**LOST CREEK ISR,  
LLC**

December 20, 2013

**Re: Responses to Letter of Violation Dated December 13, 2013, Item 6  
Permit 788**

**LOST CREEK ISR, LLC**  
**FIGURE 1**  
**PROJECT WATER BALANCE**  
**DECEMBER 18, 2013**  
 ISSUED FOR: WDEQ-LQD DRAWN BY: SMH  
 ISSUED/REVISED: DECEMBER 18, 2013  
 DWG NO: WDEQLQD FIGURE 1 12.18.13 SMH

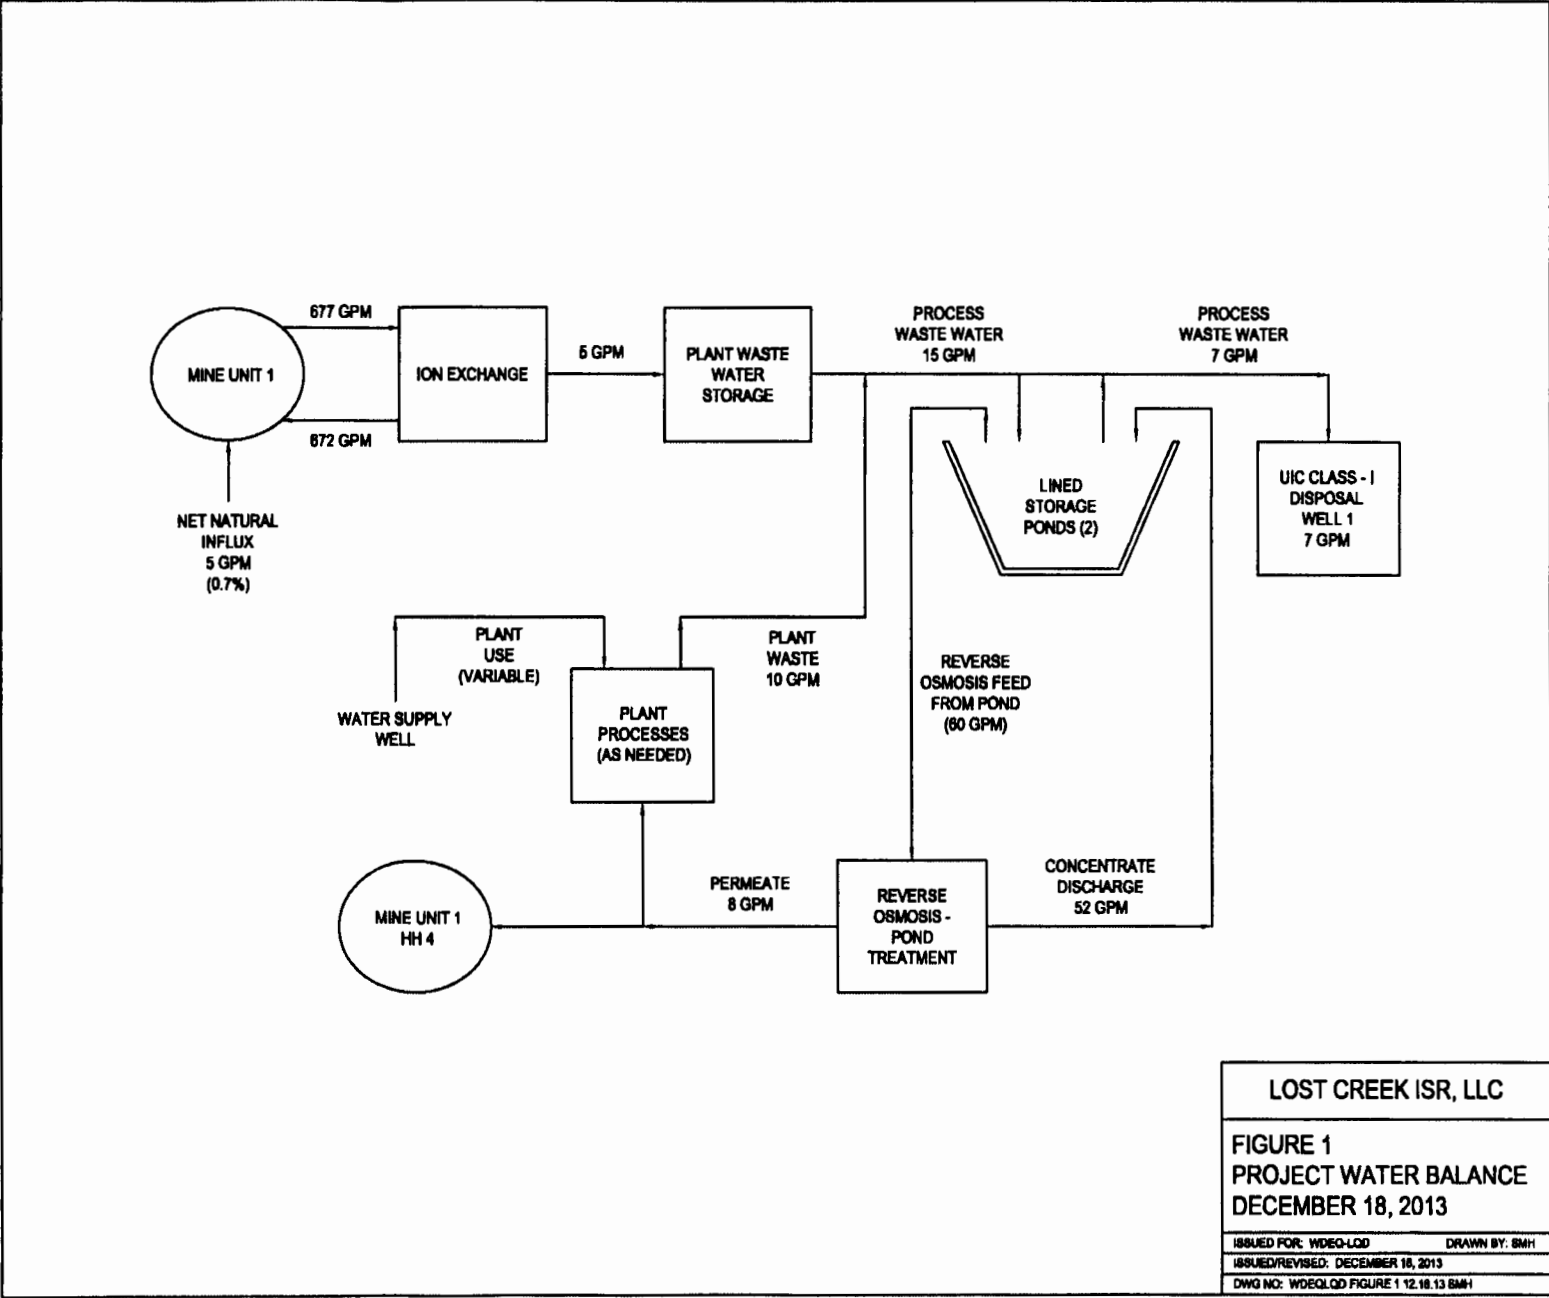
**Item 5: Provide an explanation of how the plant capacity and disposal capacity problems are currently being handled and how the future capacity problems will be addressed or avoided in the future. Include injection test results for the new disposal well.**

Figure 1, "Project Water Balance – December 18, 2013" details the current operating status of production systems at the Lost Creek Project. A more detailed discussion of the components of interest follows:

Mine Unit 1 (MU-1) production is currently operating at approximately 675 gpm, at a recent average, from header houses (HH) 1, 2 and 3. A bleed of approximately 0.7% (approximately 5 gpm) is being removed from the production stream and run through a secondary ion exchange or "guard" column for additional uranium capture. This bleed stream is then transferred to the waste water tanks and/or the lined storage ponds.

The reverse osmosis (RO) units are being used to treat the storage pond water. They are being fed with approximately 60 gpm of stored water. The ROs generate a stream of concentrate (approximately 52 gpm) which is sent to the storage ponds and/or the waste water tanks and a stream of clean permeate (approximately 8 gpm). The permeate stream is dealt with in two possible ways:

Waste water, consisting of wellfield bleed, plant process water and RO concentrate is currently being injected into LCDW-1 at a rate of approximately 7 gpm.
